**Reference: Pickett Mountain Mine Rezone Petition, ZP779A**

On behalf of Wolfden Mt. Chase, LLC (“Wolfden”), this letter provides responses to the Land Use Planning Commission (LUPC) comments in its July 13, 2023 letter to Wolfden pursuant to the Application for Zone Change for the Pickett Mountain Mine, ZP779A, referred to herein as the “Project,” and review of technical consultant and agency comments provided with that letter.

# Picket Mountain Planned Development Subdistrict (Pickett Mtn. D-PD) Development Plan

Figure-1: Delineated Wetland Acreage

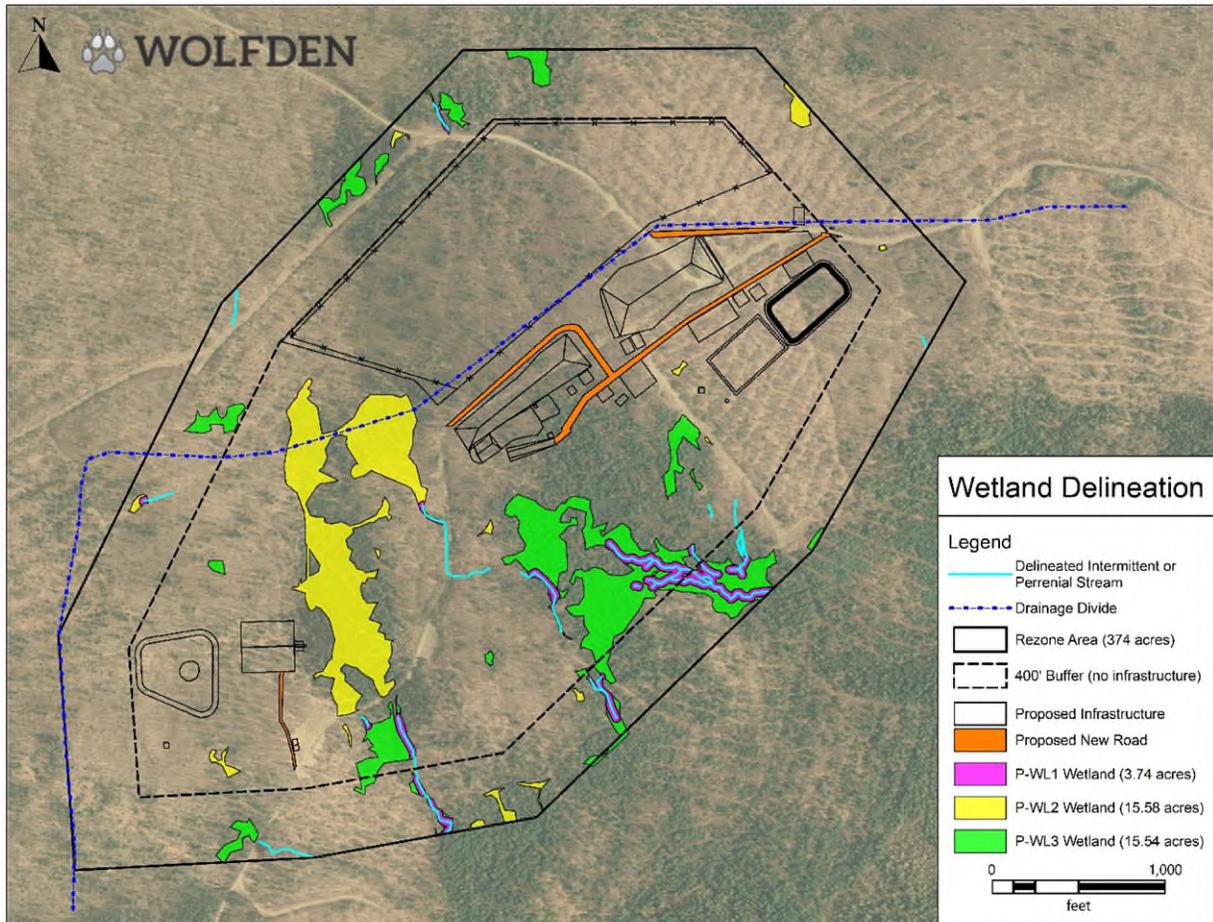
The applicant concurs with the description of what must be included as part of the baseline characterization surveys under Chapter 200. Clarification of Attachment 6A and Exhibit 10.0 is provided below.

Within the Project Area, there are 3.74 acres of Wetlands of Special Significance (P-WL1), 15.58 acres of Scrub-shrub Wetlands (P-WL2), and 15.54 acres of Forested Wetlands (P-WL3).
